# UNITED STATES PATENT AND TRADEMARK OFFICE

APPLICATION NO.	FILING DATE	FIRST NAMED INVENTOR	ATTORNEY DOCKET NO.	CONFIRMATION NO.
10/723,126	11/25/2003	Donald R. Gilbreath	C02-085A	9442
26683	7590	06/07/2007	EXAMINER	
THE GATES CORPORATION			DUNWOODY, AARON M	
IP LAW DEPT. 10-A3			ART UNIT	PAPER NUMBER
1551 WEWATTA STREET				
DENVER, CO 80202			3679	
MAIL DATE	DELIVERY MODE			
06/07/2007	PAPER

<b>Office Action Summary</b>	Application No.	Applicant(s)
	10/723,126	GILBREATH, DONALD R.
	Examiner Aaron M. Dunwoody	Art Unit 3679

FIG. 4

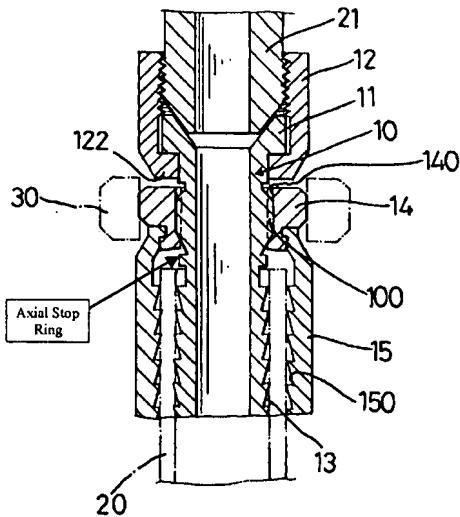
In regards to claims 1 and 2, Huang discloses an improved hydraulic fitting having a stem (10) including a hose insert portion, and a collar support portion, having a mating connection portion, and a collar having, a torque communication portion, a female support portion, and an inner periphery extending through the ferrule support portion and the torque communication portion, the improvement comprising:

the collar support portion including a *spline* and an axial stop ring (see Figure 4 below),

the torque communication portion adapted to be staked in such a manner that the inner periphery extending through the torque communication portion communicates with the knurling in a relatively non-rotational manner, and

the ferrule support portion adapted to be staked in such a manner that the inner periphery extending through the ferrule support portion communicates with the axial stop ring in an axial movement limiting manner.

Huang does not disclose the collar support portion including knurling. Salyer teaches substituting splines (801) and knurling (724), "so that the tubing is effectively gripped" (col. 7, line 46-47). It would have been obvious to one having ordinary skill in the art at the time the invention was made to substitute splines with knurling, so that the tubing is effectively gripped, as taught by Salyer.
